*Final Environmental Impact Statement*

# Shutdown of the River Water System at the Savannah River Site

**May 1997**

**COVER SHEET****RESPONSIBLE AGENCY:** U.S. Department of Energy (DOE)**TITLE:** Final Environmental Impact Statement, Shutdown of the River Water System at the Savannah River Site, Aiken, South Carolina (DOE/EIS-0268).**CONTACT:** For additional information on this statement, write or call:

Figure A-1. Data points used for L-Lake remedial options analysis.

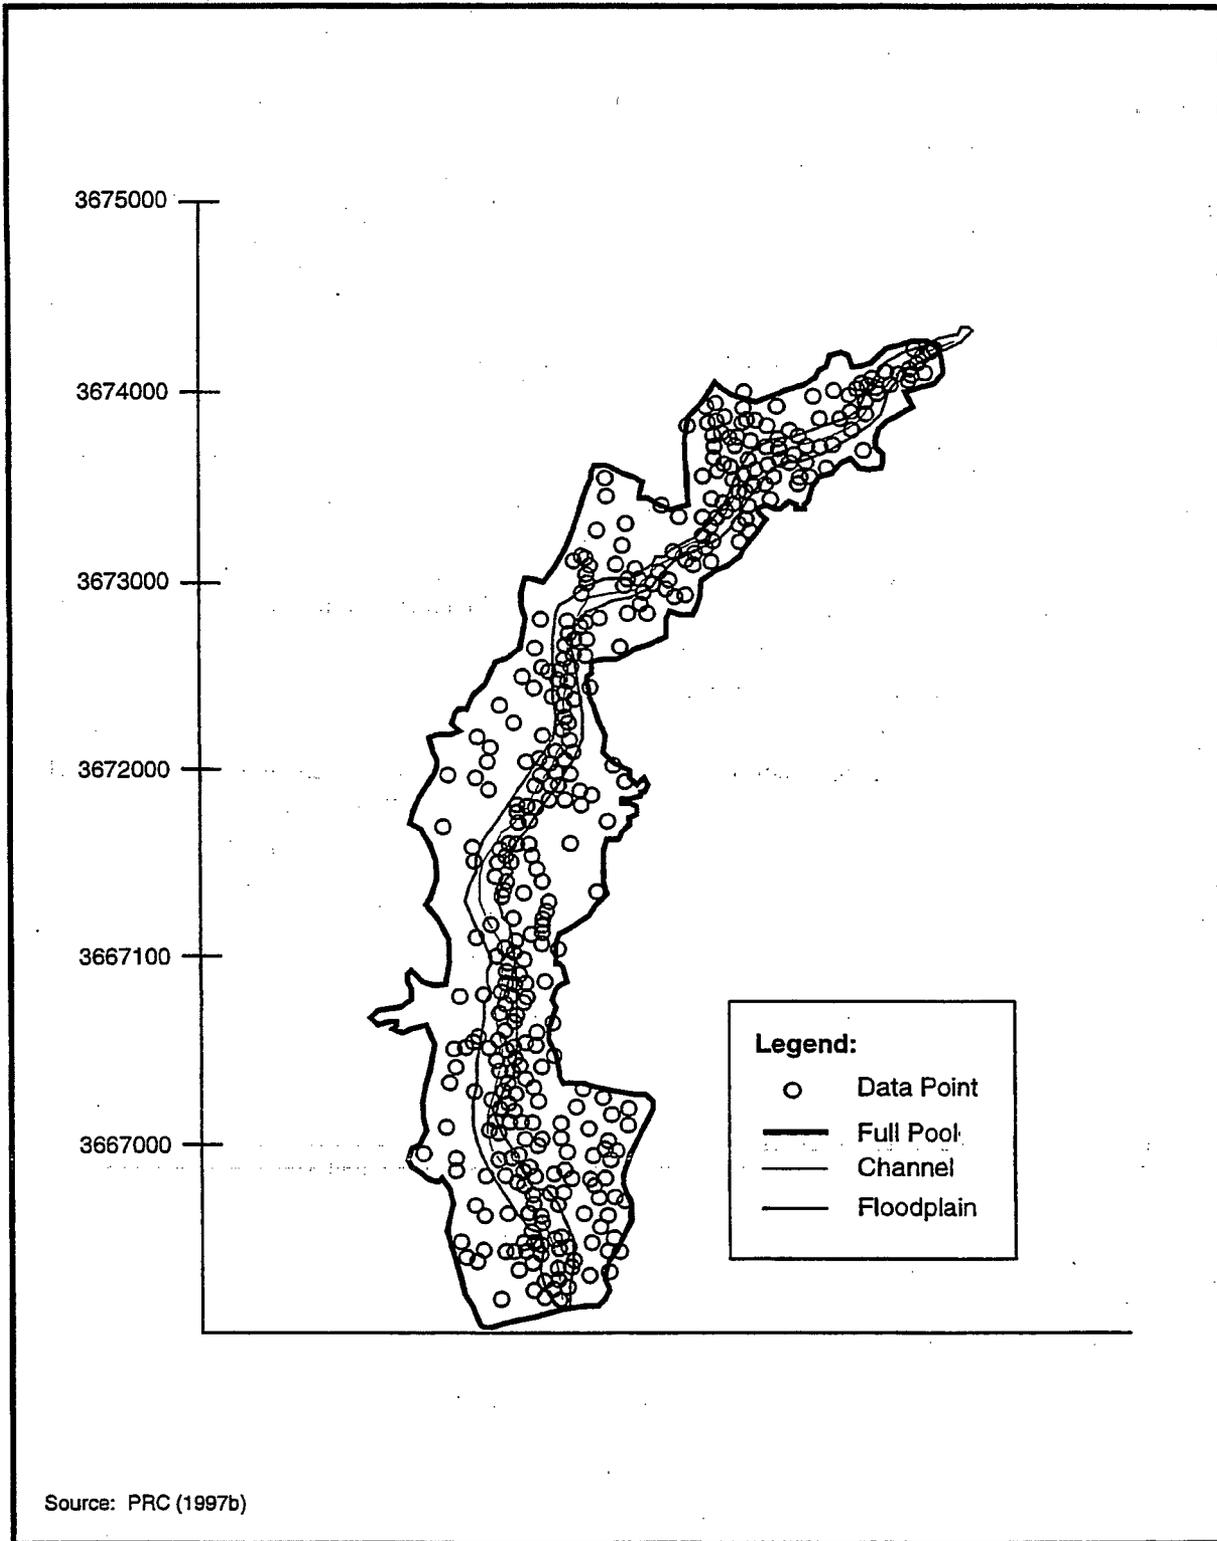
publish a draft EIS without having validated this data for use in assessing the affected environment. It is clear that Figure A-1 on page A-6 was composed using this unvalidated data. This was improper because it allows authors of the DEIS to present a synthesis of data without producing the underlying data that supports the presentation. Furthermore, it was improper not to publish a disclaimer on Figure A-1, noting the fact that it was composed using unvalidated data.

3) Figure A-1 on page A-6 should be recomposed using validated data from sediment samples. The figure should, to the extent practicable, provide the locations of specific sampling locations so readers can get a clearer sense of how the designated isopleths are composed. It should also include a depiction of the areas greater than 2 picocuries per gram of sediment Cs-137 because it is this level of contamination that would (assuming the formula being used in the DEIS for these conversions is accurate) reach the  $10^{-4}$  risk level for the residential scenario, a more likely threshold for remediation than the  $10^{-6}$  risk level for the residential scenario that is presented (along with two worker scenario risk projections) in Figure A-1.

DOE included Figure A-1 in the FEIS to show data points upon which the remedial options study is based. The revised remedial goal option for the onsite worker scenario at the  $10^{-6}$  risk level presented in the FEIS is not representative of  $10^{-4}$  risk level for the residential scenario as was the case for the DEIS. Therefore, the FEIS was revised to separately evaluate the onsite resident at the  $10^{-4}$  risk level in the remedial options analyses presented in Appendix A.
